Town of Brookline

PLANNING BOARD

To: Brookline Board of Appeals
From: Brookline Planning Board
Date: March 17, 2016
Subject: Install a surface parking area within the required front yard
Location: 63 Hillside Road

Atlas Sheet:	84	Case #:	2016-0005
Block:	336	Zoning:	S-15
Lot:	01	Lot Area (s.f.):	±49,749

PROPOSED LAYOUT PLAN
#63 HILLSIDE ROAD
IN
BROOKLINE, MASS

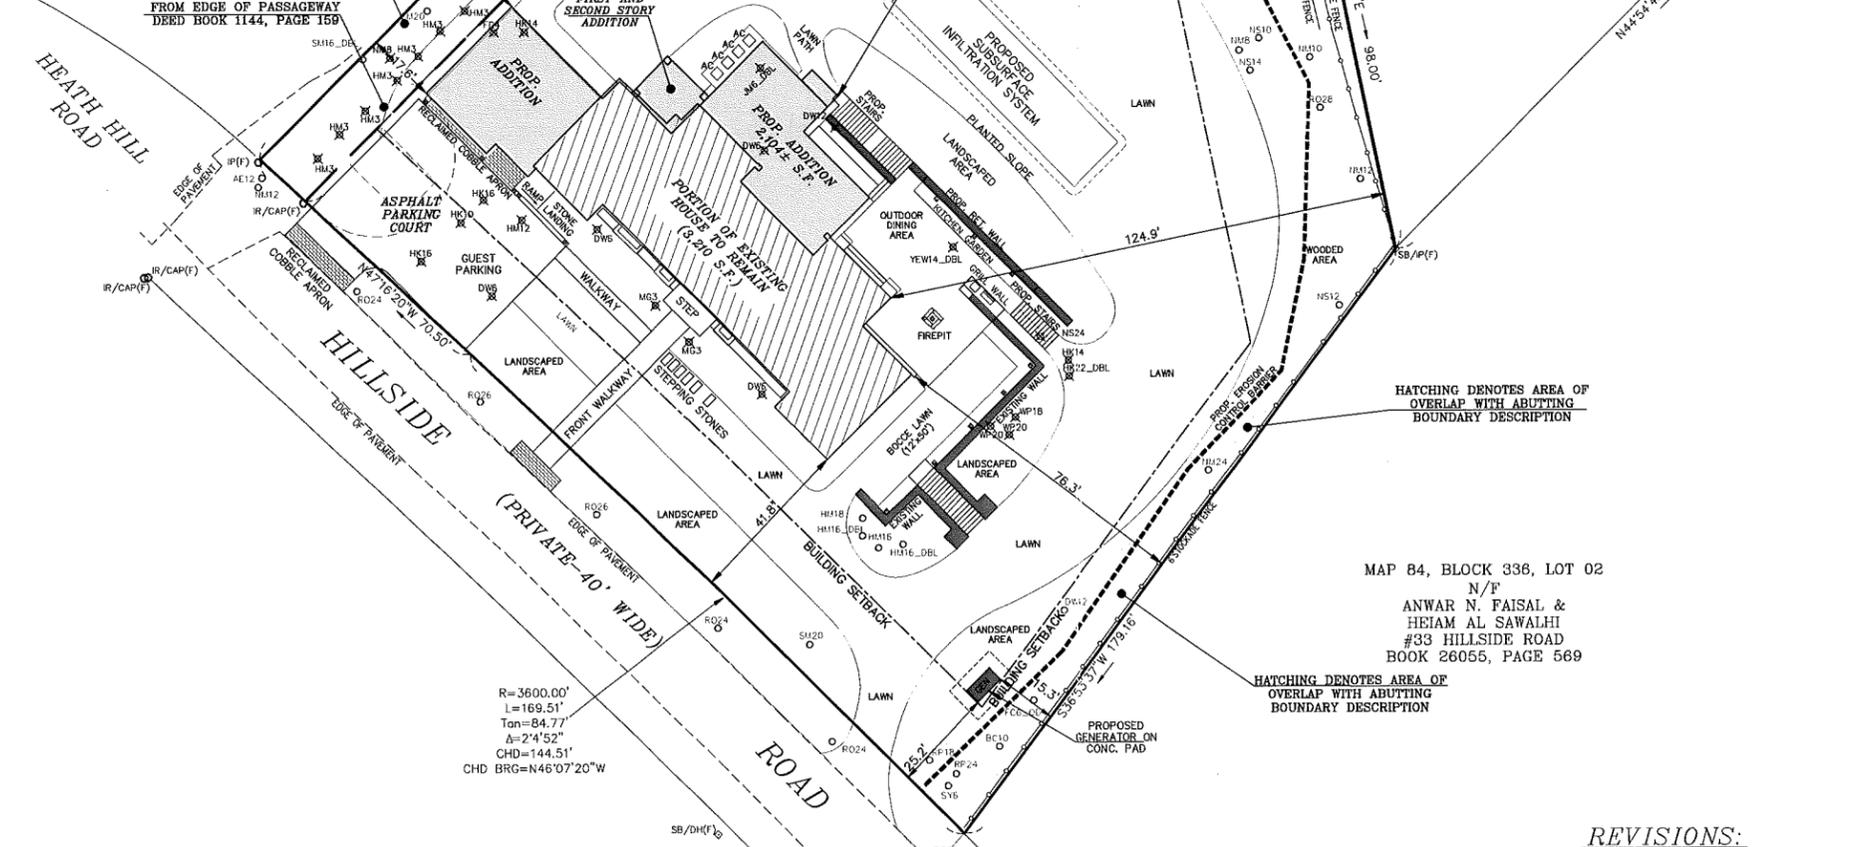
The Planning Board does not support this request to install an expanded front-yard parking area in front of the new two car parking garage. If the garage had been located further back on the lot, the visitor parking could have been set back from the street. Additionally, with this being a dead-end private way backing out onto the street should not present a safety issue. The Board is more sympathetic to turn around areas when a property is located on a heavily travelled road. This expanded parking area results in impermeable surface replacing open space and existing trees, and no landscaping plan has been presented at this time to serve as a counterbalancing amenity to off-set the relief requested.

Therefore, the Planning Board recommends denial of the site plan submitted by Metrowest Engineering, Inc., dated 11/6/2015.
